**PARCEL G REMOVAL SITE EVALUATION
WORK PLAN**

**FORMER HUNTERS POINT NAVAL SHIPYARD
SAN FRANCISCO, CA**

June 2019

DCN: CH2M-9000-FZ12-0013

Figure ES-1
Soil and Building Sites
 Parcel G Work Plan
 Former Hunters Point Naval Shipyard
 San Francisco, California

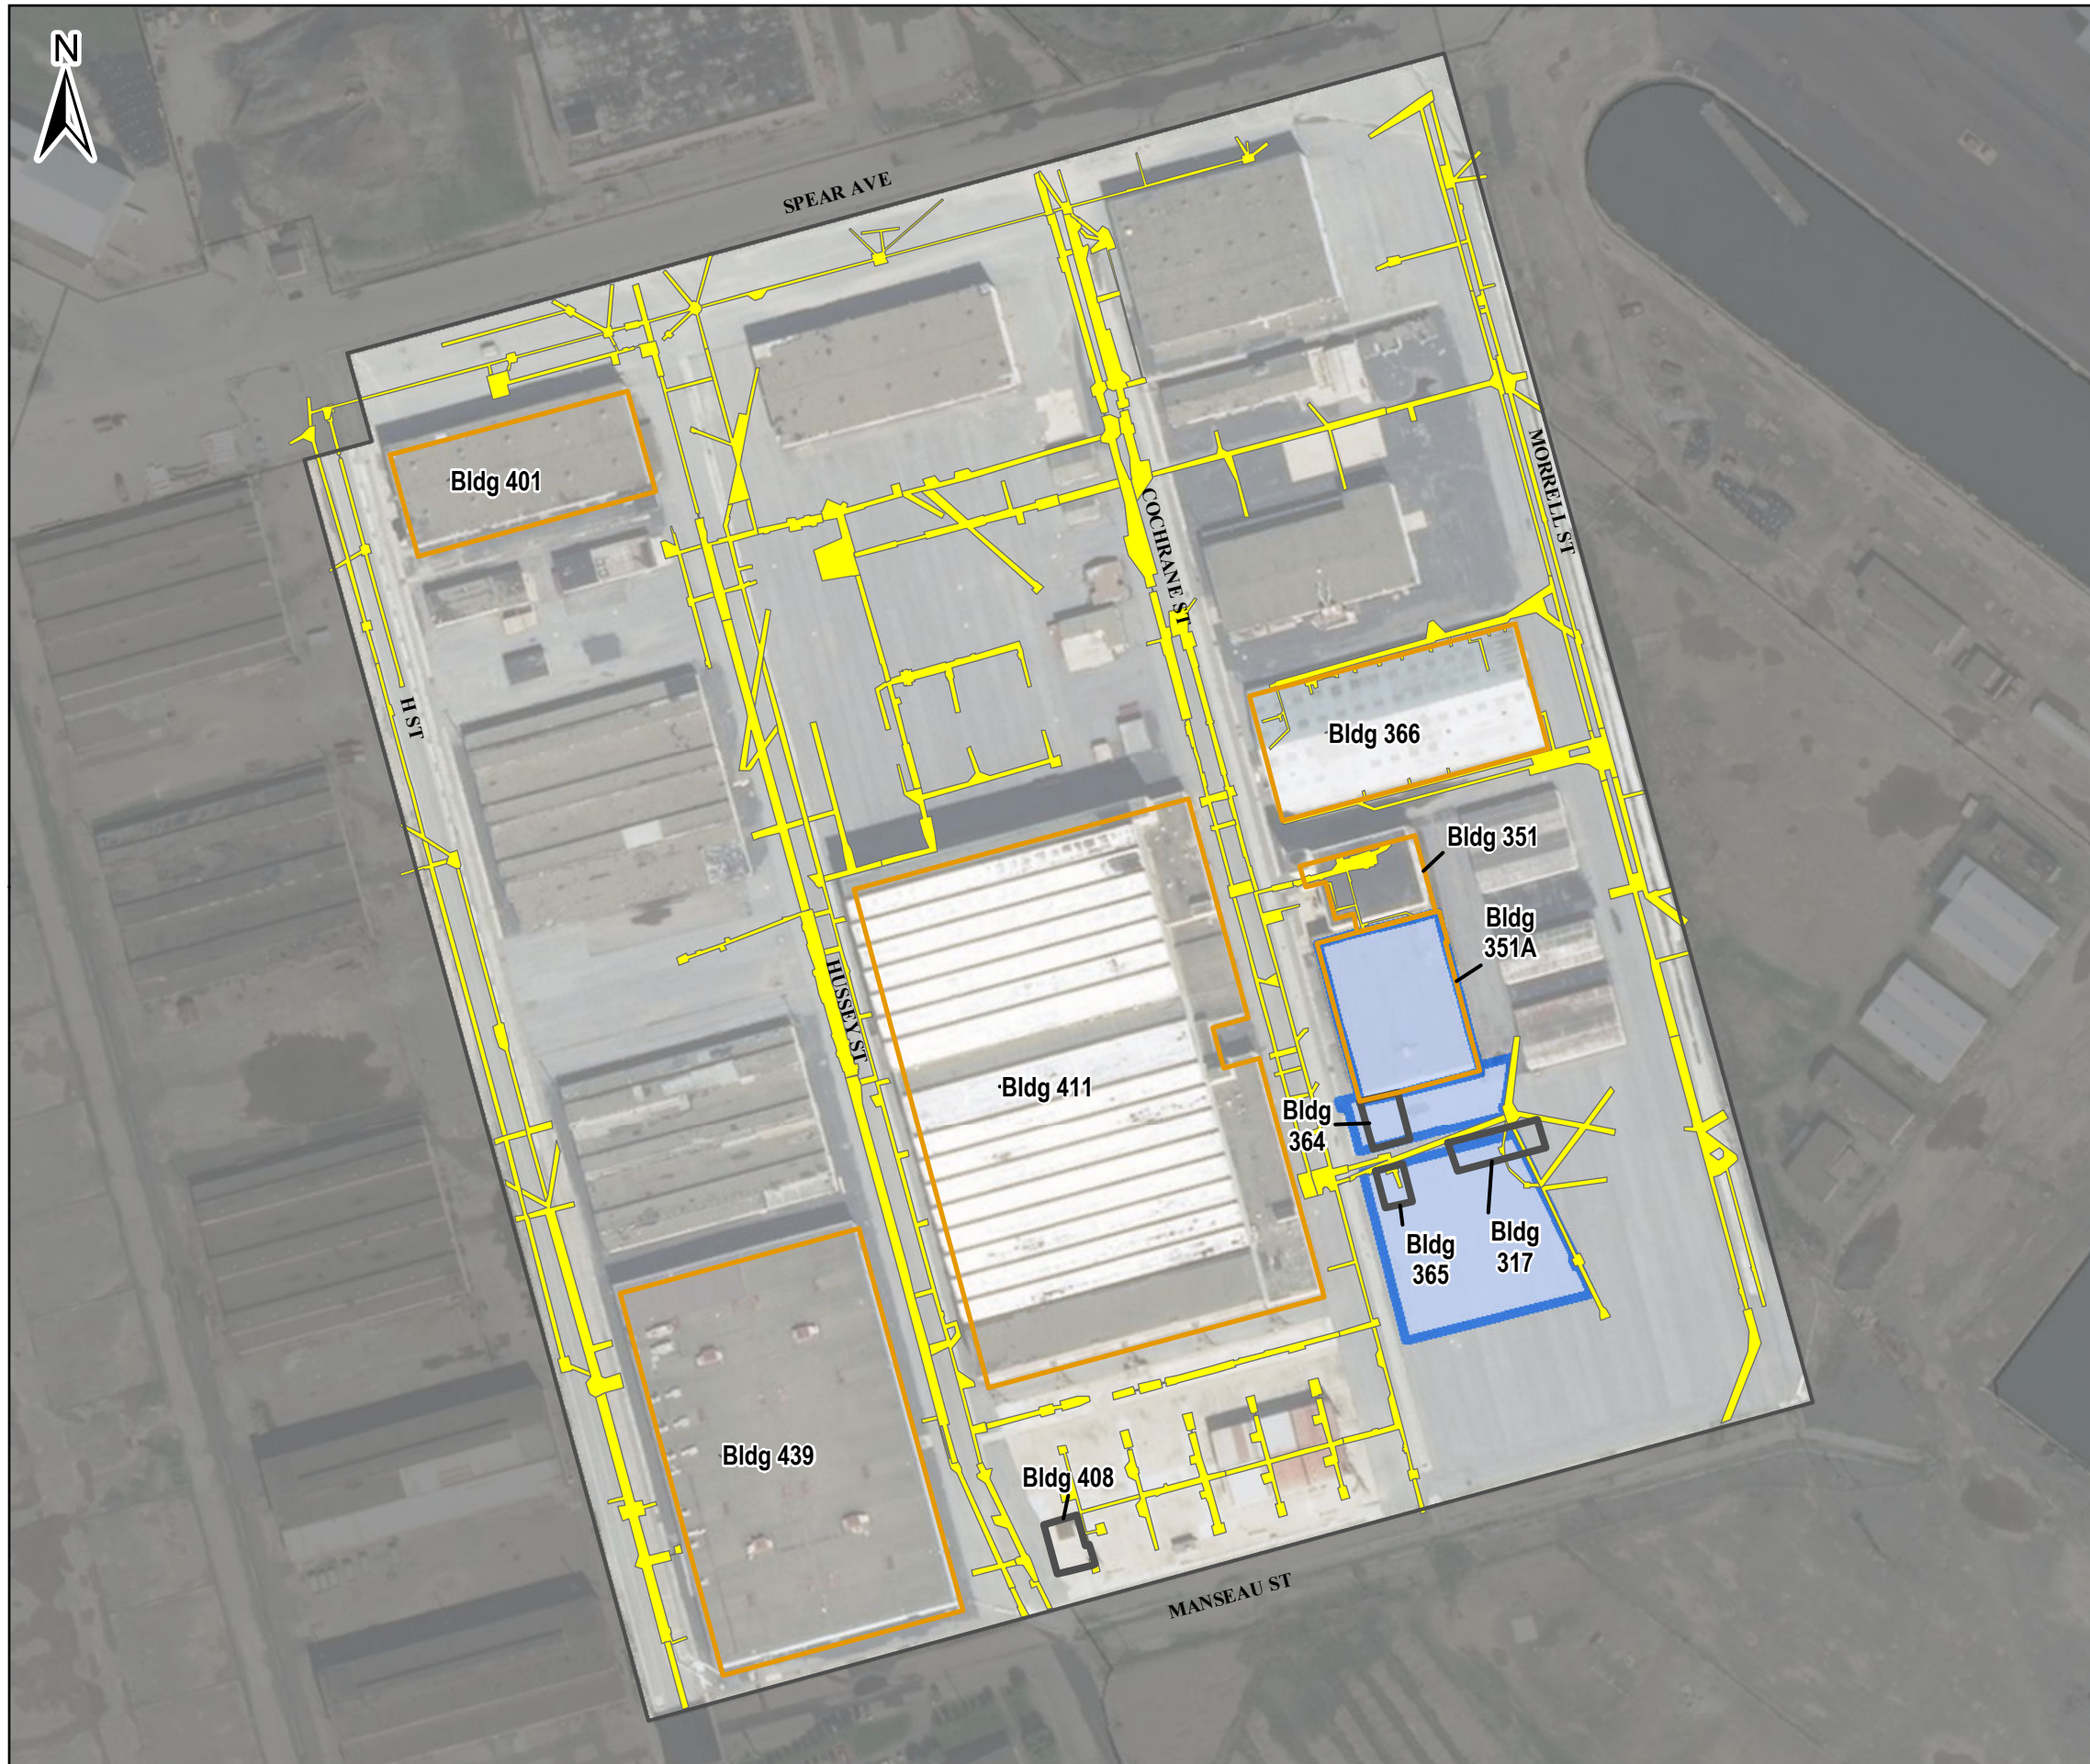
17. Table ES-1. Soil and Building Trench and Survey Units: Figure ES-1. Soil and Building Sites. Please refer to the United States Environmental Protection Agency (USEPA) Review of the Draft Parcel G Removal Site Evaluation Work Plan, Hunters Point naval Shipyard, San Francisco, California, June 18, 2018, USEPA Review dated August 14, 2018; comments for specific areas to be surveyed.

4. Executive Summary, Soil Investigations, Page IV and Figure ES-1, Soil and Building Sites: The text states that the approximate size and boundary of the TUs and SUs are shown on Figure ES-1. Please consider revising to state that the buildings and former buildings (of interest for this study) and the storm drain and sanitary sewer trench outlines are shown on Figure ES-1. Or consider deleting this sentence as TUs and SUs are not specifically identified on Figure ES-1. Or you could insert a Figure like 3-1 that does identify TUs and SUs?

Figure 3-1
Soil Investigation Approach
 Parcel G Work Plan
 Former Hunters Point Naval Shipyard
 San Francisco, California

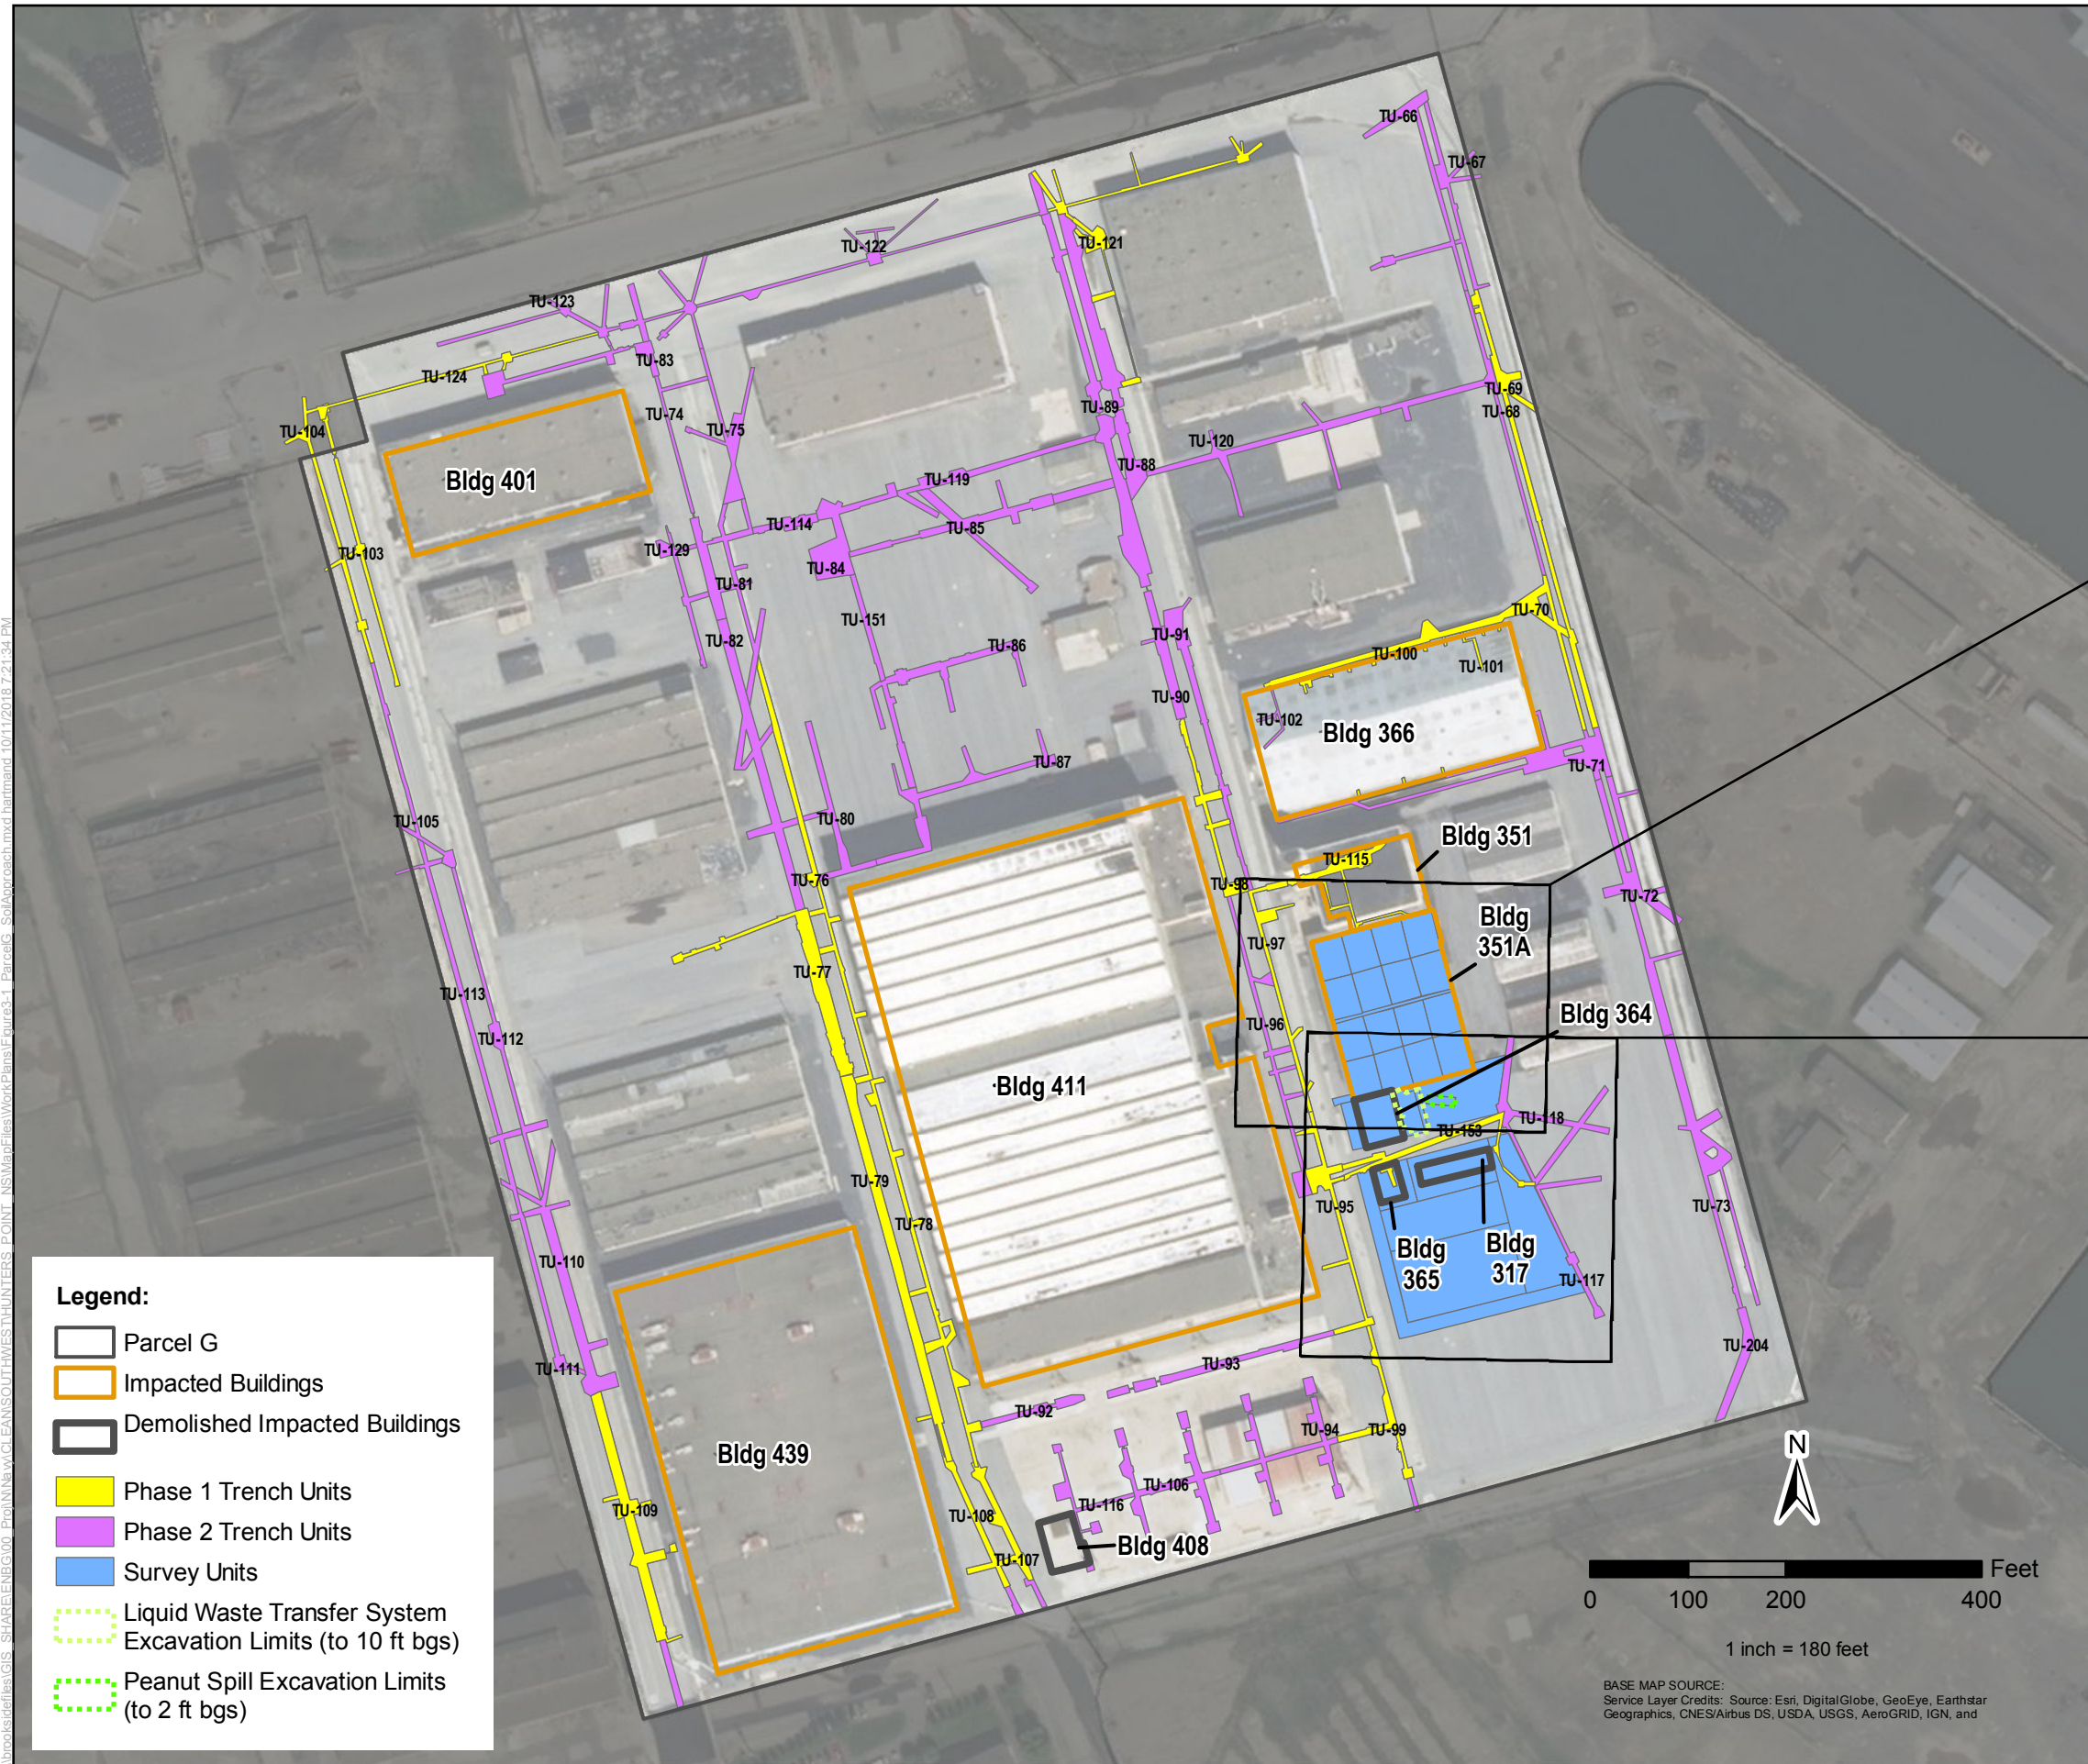
6. Section 3.54.6, Former Building Site and Crawl Space Unit Design. page 3-10, paragraph four, sentence one: At the former Building Sites: SU 27 (peanut spill) and SU 28 ((LWTS) will be excavated to 2 and 10 feet bgs, respectively (Figure 3-1)."Please make clear in the text that these excavations will also receive MARSSIM based soil sampling/surveys. Additionally, please clarify if the crawl space below the building 351A will be excavated prior to MARSSIM based soil sampling/surveys.

The text in Section 3.4.6 will be updated to read as follows (new text is underlined): “At the Former Buildings 317/364/365 Site, SUs 27 (peanut spill) and 28 (LWTS) will be excavated to 2 and 10 feet bgs, respectively, for consistency with the previous excavation boundaries (Figure 3-1).”

The text in Section 3.4.6 will be updated to read as follows (new text is underlined): “At the Former Buildings 317/364/365 Site, SUs 27 (peanut spill) and 28 (LWTS) will be excavated to 2 and 10 feet bgs, respectively, for consistency with the previous excavation boundaries (Figure 3-1).” The excavations will receive MARSSIM based soil sampling/surveys. The Building 351A crawl space is not planned for excavation prior to soil sampling/surveys.
